UNITED STATES PATENT AND TRADEMARK OFFICE

APPLICATION NO.	FILING DATE	FIRST NAMED INVENTOR	ATTORNEY DOCKET NO.	CONFIRMATION NO.
10/538,413	06/10/2005	Helmut Rupp	2004P84076WOUS	3589

Office Action Summary

DETAILED ACTION

3,773,336

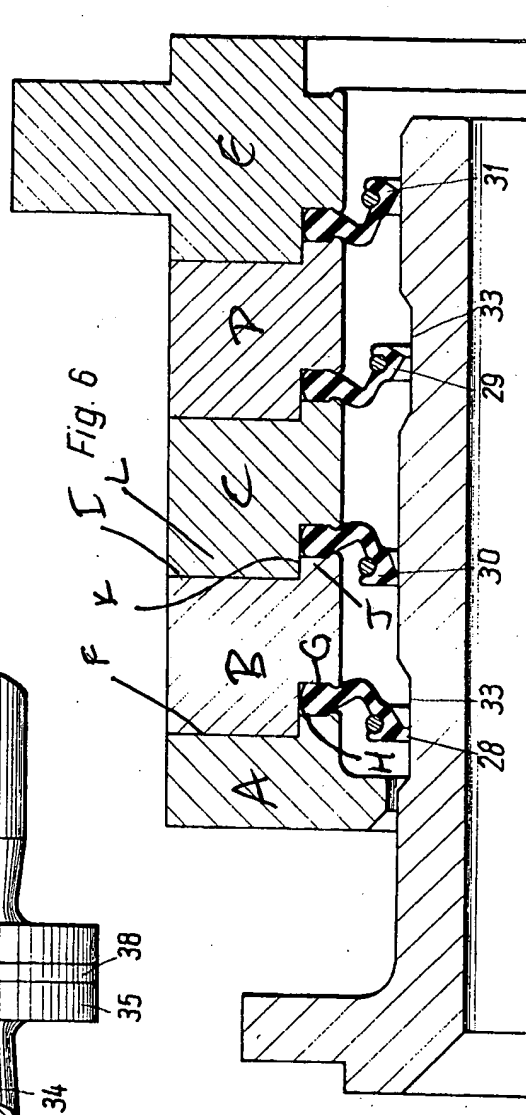
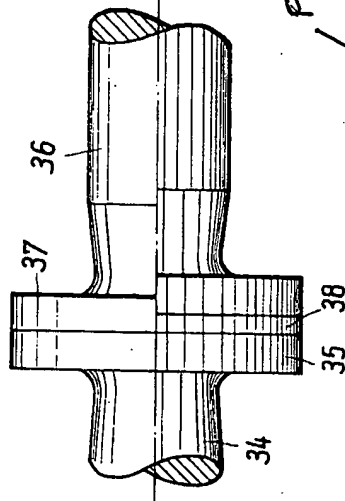
Regarding claim 12, the Walter et al. reference discloses a seal (Fig. 6) sealing a gap between a rotor (e.g. 17) and a stator (e.g. 15), comprising:

a ring (e.g. 28-31) and at least two annular ring carriers (e.g. A-E) extending in the circumferential direction of the rotor (Fig. 6), each ring being fixed between a first end face (F) of a first brush carrier (e.g. A) and a second end face (G) of a second ring carrier (e.g. B), and the second ring carrier being directly fixed axially and radially to the first ring carrier (Fig. 6),

wherein the second ring carrier is fixed to the first ring carrier by an unreleasable snap connection (Fig. 6), including the ring being a lip ring (Fig. 6).

Regarding claim 13, the Walter et al. reference, as modified in claim 12, discloses a slot (H) being formed between the first brush ring carrier and the second brush ring carrier and the slot receiving the brush ring (Walter et al., Fig. 6).

Regarding claim 14, the Walter et al. reference, as modified in claim 12, discloses at least one brush ring carrier (B) having on its first end face (I) a shoulder with a circumferential slot (K) and at least one second brush ring carrier (C) having on its second end face (e.g. face of element C in contact with I) a continuous projection (I), with a latching nose (e.g. portion of element C latched to element J), and the projection and the latching nose of the second brush ring carrier cooperating with the shoulder and with the circumferential slot of an adjacently arranged first brush ring carrier (Fig. 6).

Regarding claim 15, the Walter et al. reference, as modified in claim 12, discloses at least one brush ring carrier (B) having on its first end face (I) a shoulder with a circumferential slot (K) and at least one brush ring carrier (C) having on its second end face (e.g. face of element C in contact with I) a continuous projection (I), with a latching nose (e.g. portion of element C latched to element J), and the projection and the latching nose of the second face of the at least one brush ring carrier cooperating with the shoulder and with the circumferential slot of an adjacently arranged brush ring carrier (Fig. 6).

Regarding claim 17, the Walter et al. reference, as modified in claim 12 and as best understood, discloses a circumferential slot (K) in a brushing ring carrier (B) and a latching nose (e.g. face of element C in contact with I).

FIG. 7D

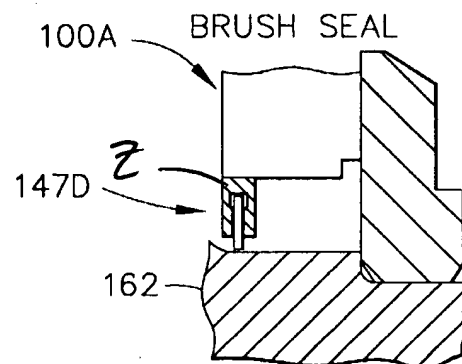
Regarding claim 18, the Walter et al. reference, as modified in claim 12 and as best understood, discloses the brush ring carriers having a support plate (e.g. Langston et al., Z) and the brush rings bearing axially against the support plate (Langston et al., Fig. 7D).

Regarding claim 19, the Walter et al. reference, as modified in claim 12, discloses the brush ring carriers having a protective ring (e.g. Langston et al., Z).

Regarding claim 20, the Walter et al. reference, as modified in claim 12 and as best understood, disclose the protective ring being radially elastic (Langston et al., Fig. 7D).
